NOTICE UNDER SCHEDULE VI CHAPTER XI, RULE 2 (I) OF
THE CITY OF KARACHI MUNICIPAL ACT 1933.

KARACHI MUNICIPAL CORPORATION
BUILDING SECTION.

REVIEW FORM.

PROPOSED BUILDING ON PLOT NO 30 SHEET NO M.M.2

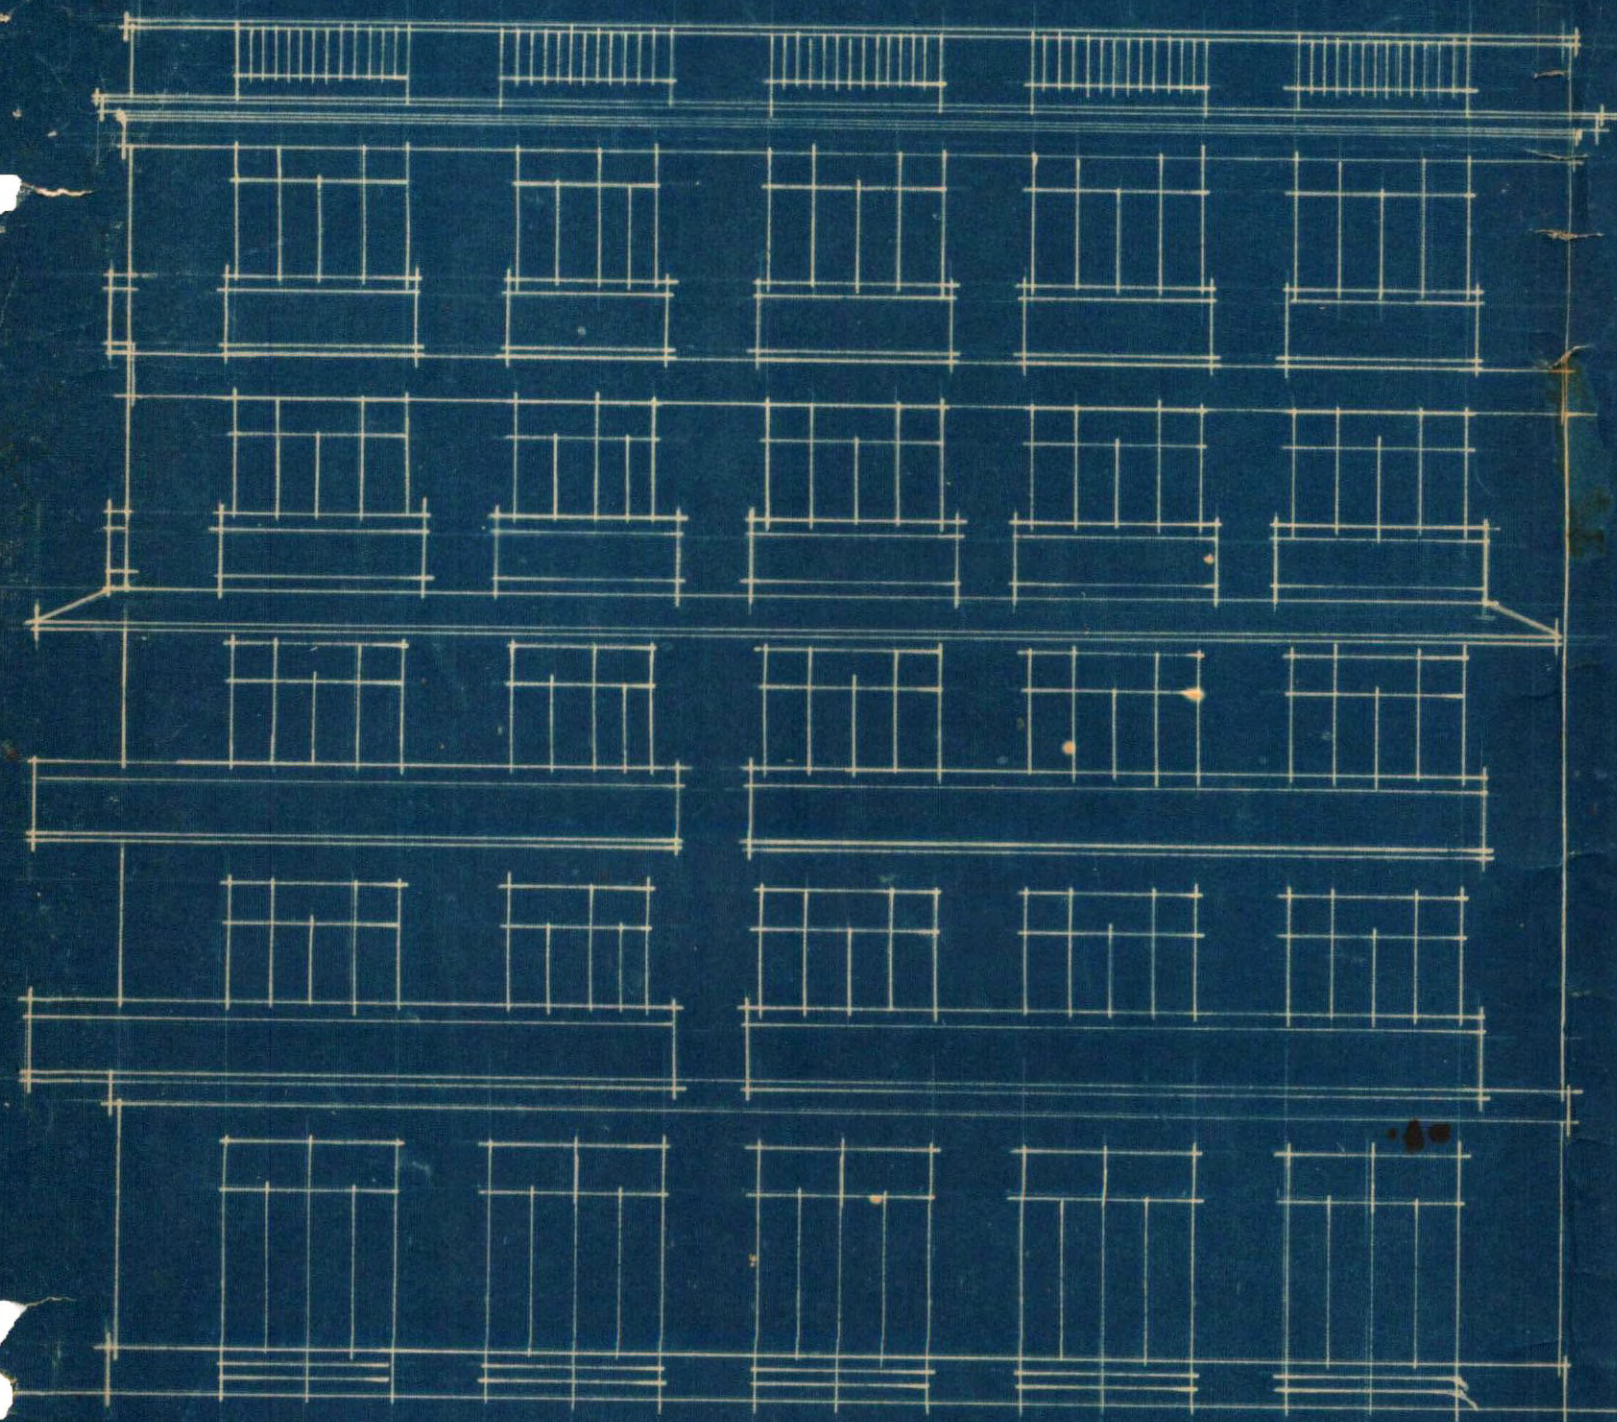
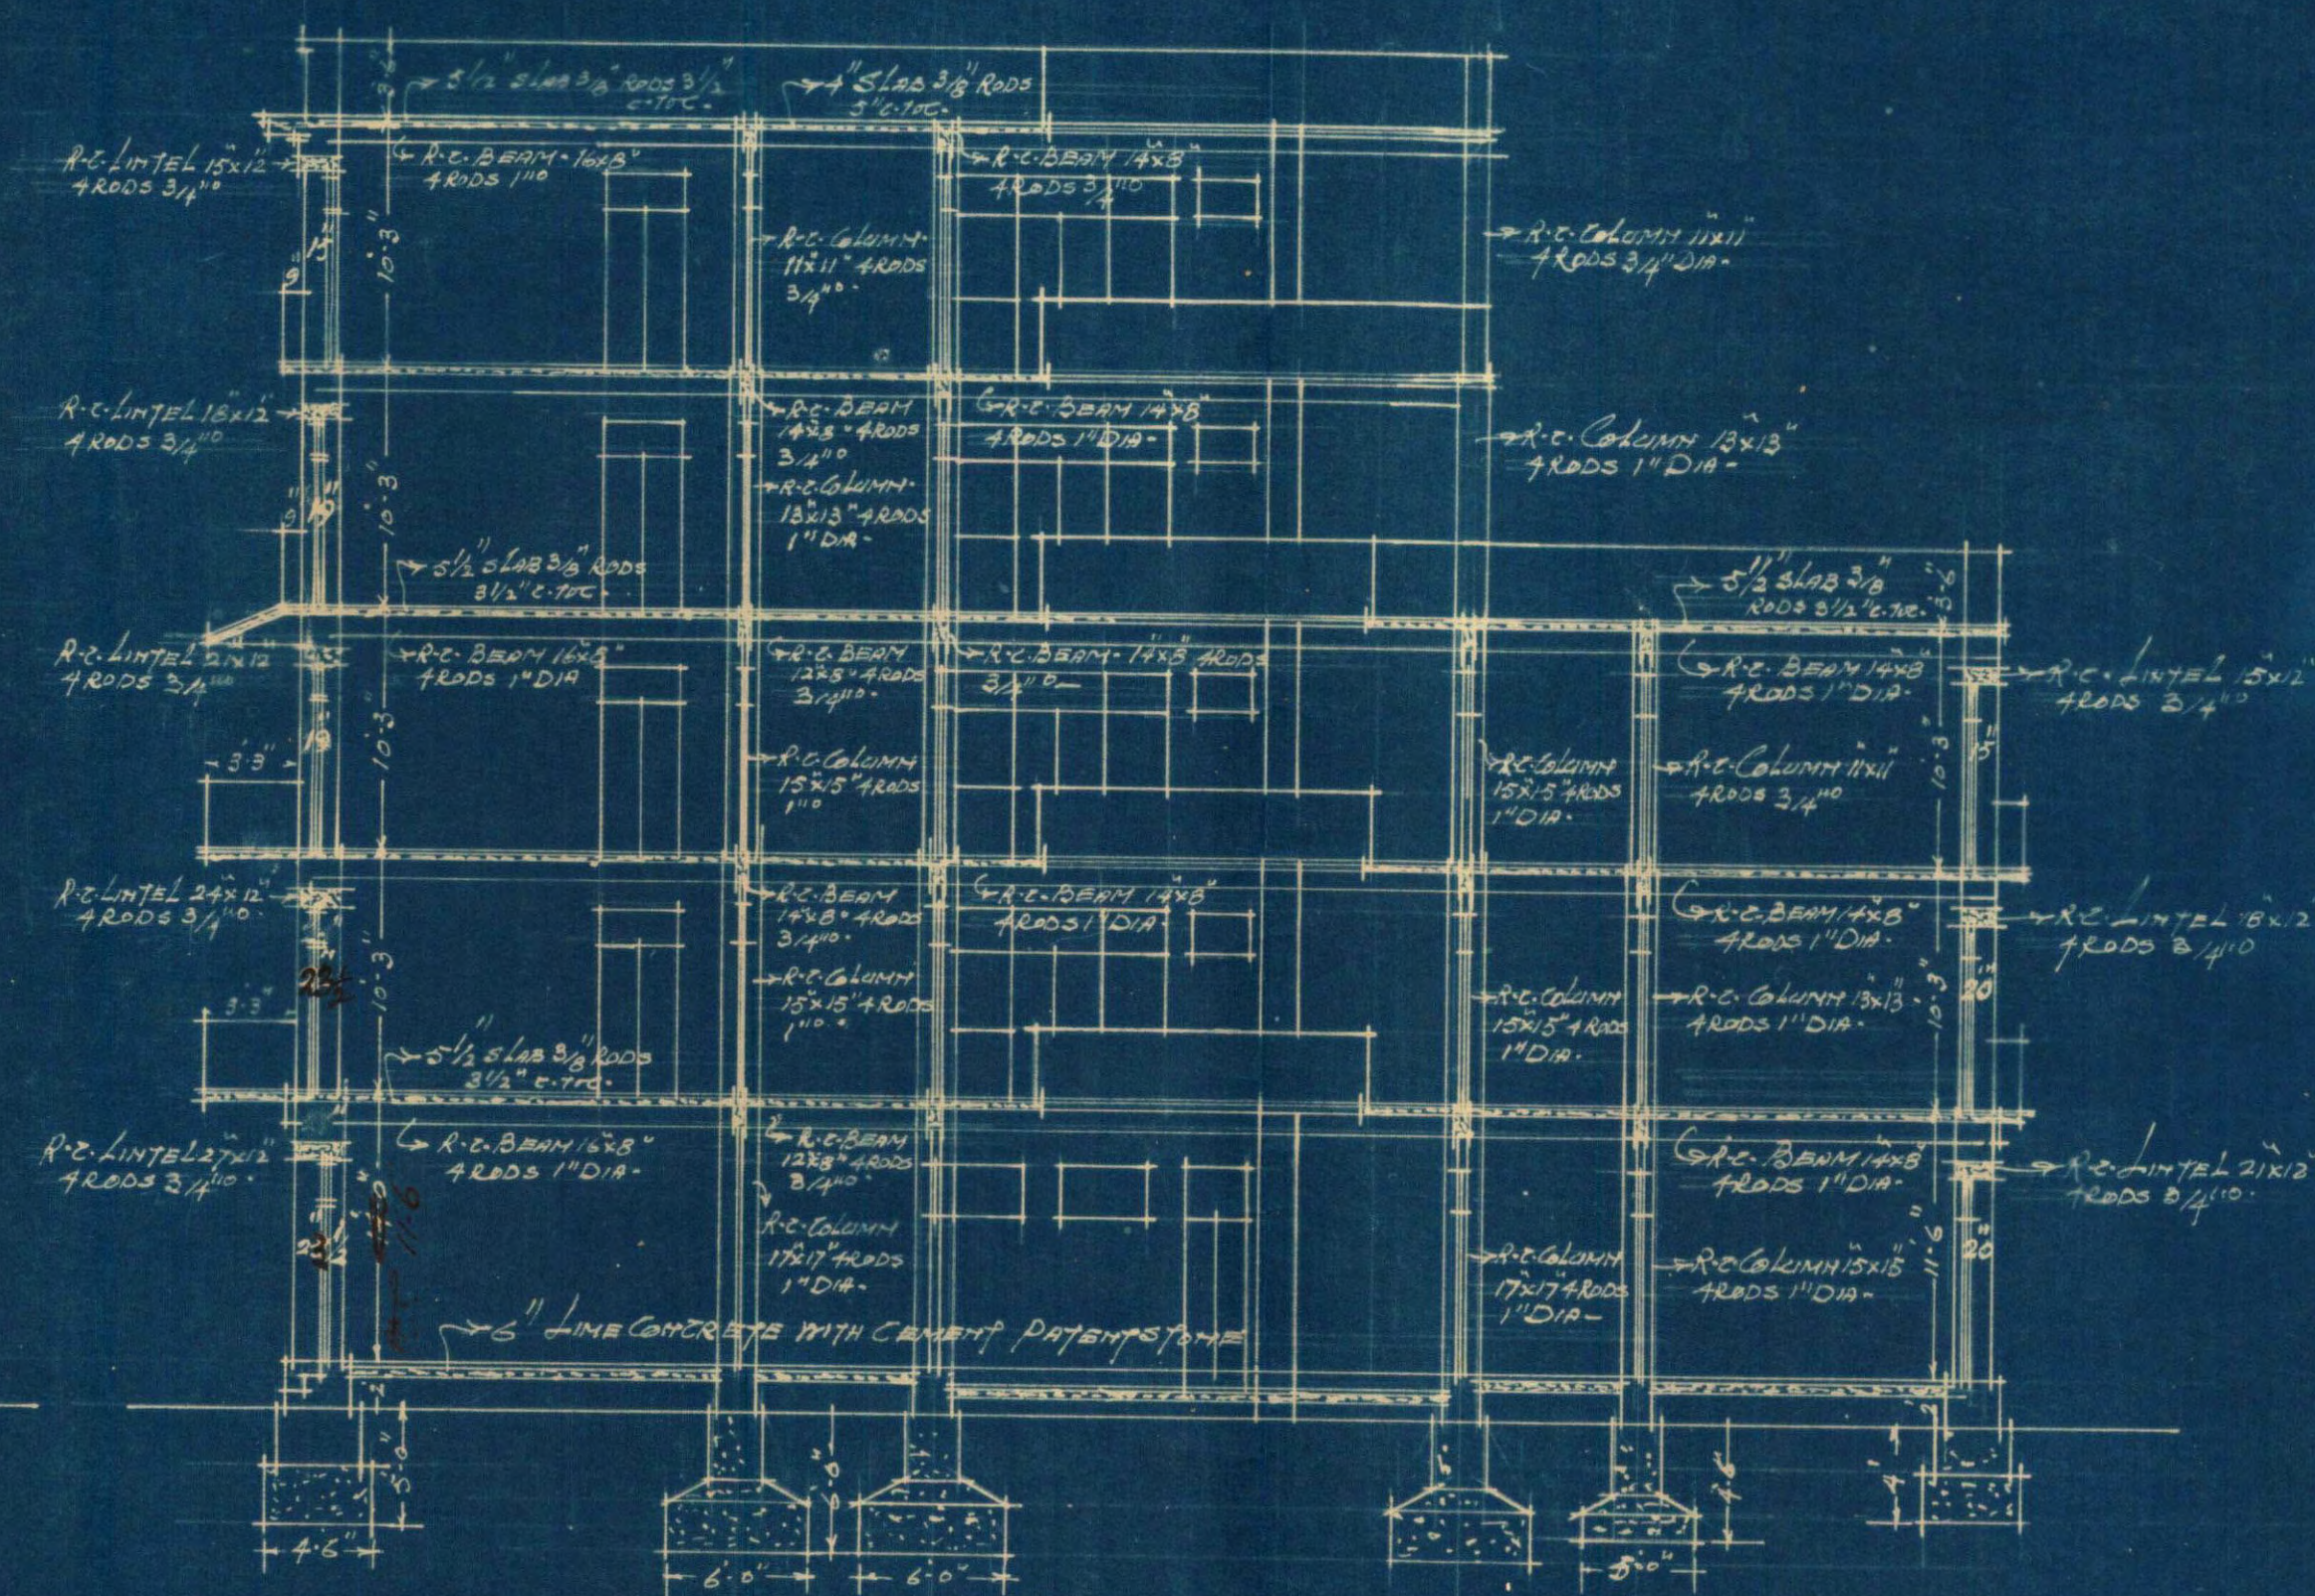
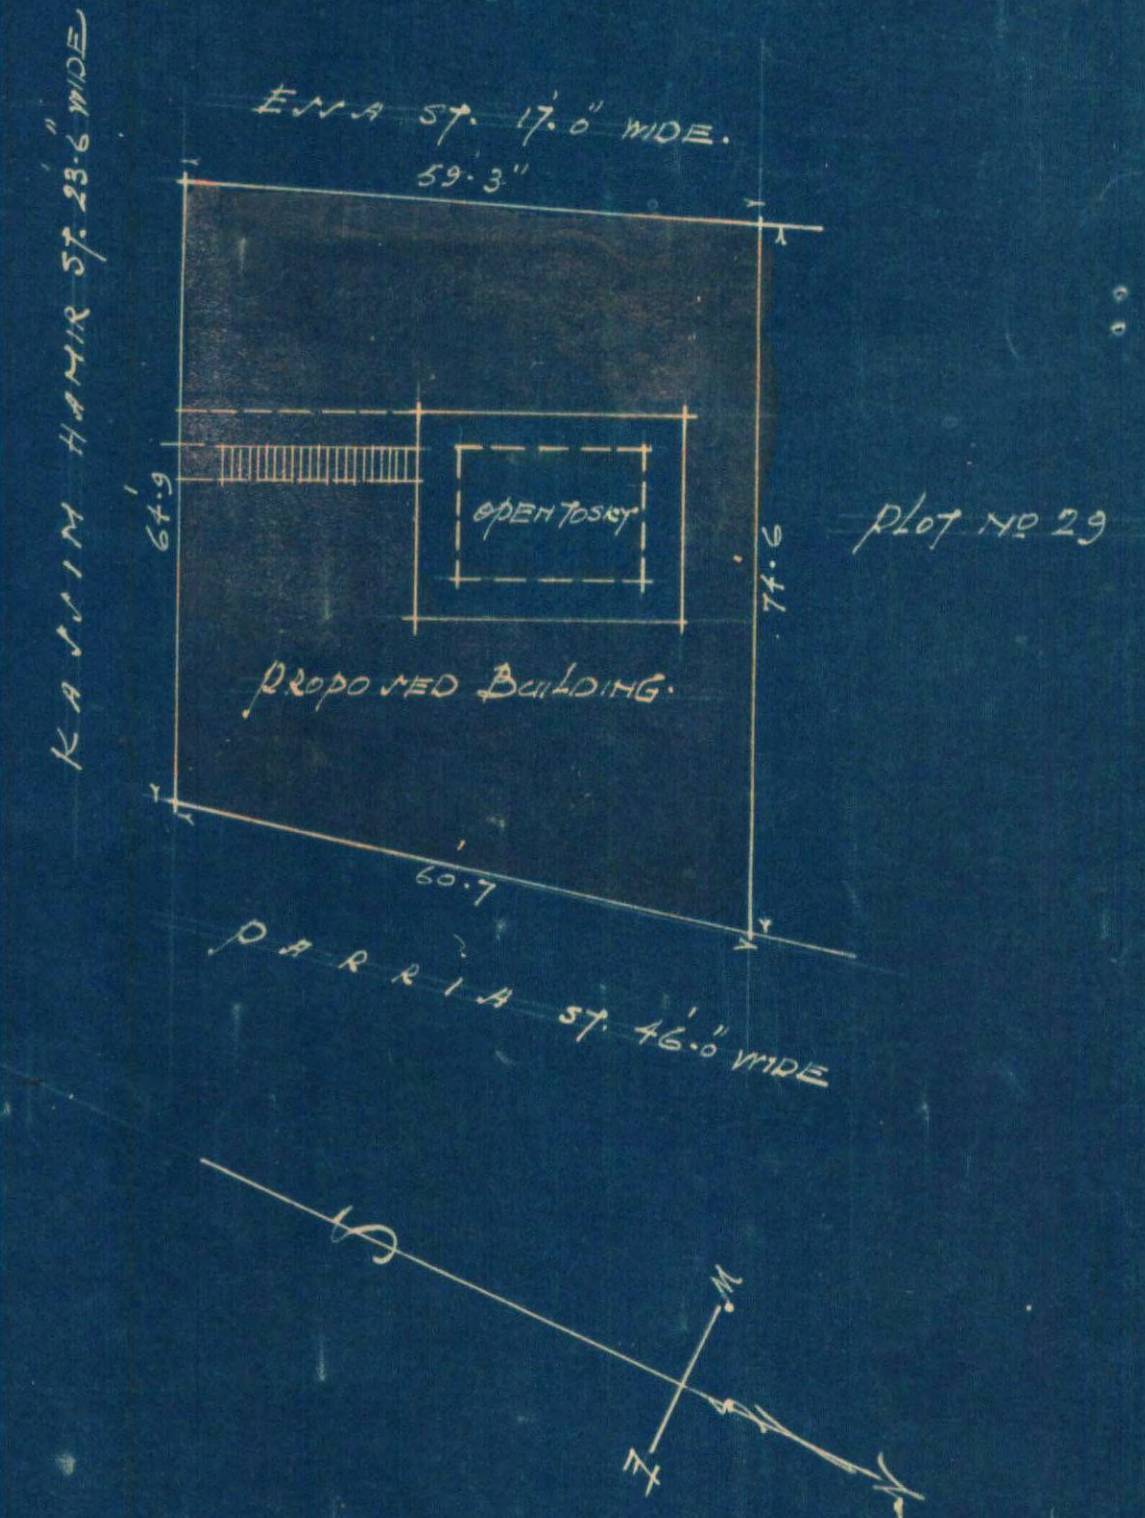
Underground water tank should be
sufficiently away from the drainage line.

The area of plot is not shown on the plan.

- (2) 1. Thickness of walls on the 1st floor must be $23\frac{1}{2}$ " in accordance with the Bombay Byelaws.
- (3) 2. The height of the building be regulated in accordance with by-law 233(4) of this Corporation.
- (4) 3. Continuous galleries are shown as proposed as here were continuous galleries before. Orders are requested whether these be restricted to 15' length and also whether weather shade be allowed on account of the existence of the old roof as shown in the attached photograph.
4. The balconies must be at the same height as the old balconies.
- (5) 5. The parapet wall on Esra Street be proposed balustraded.

1. Underground water tank should be sufficiently away
from the drainage line.
2. The thickness of walls on the first floor must be $23\frac{1}{2}$ ".
3. The height of the building be regulated in accordance
with bye law 233(4) of this Corporation.
4. Galleries be proposed at the same height at which they
were existing as before and they be limited to 15'-0
long & only.
5. The parapet wall on Essa street be proposed balustrated.

With reference to your office No.BSP 626/36
dated 17th instant and as personally arranged with your
goodself, we beg to return herewith the plans complying
with your objections Nos.1, 2, 4 & 5 and shall thank you
to kindly return us the same duly approved.

There is no objection as per connected
position of the tank.
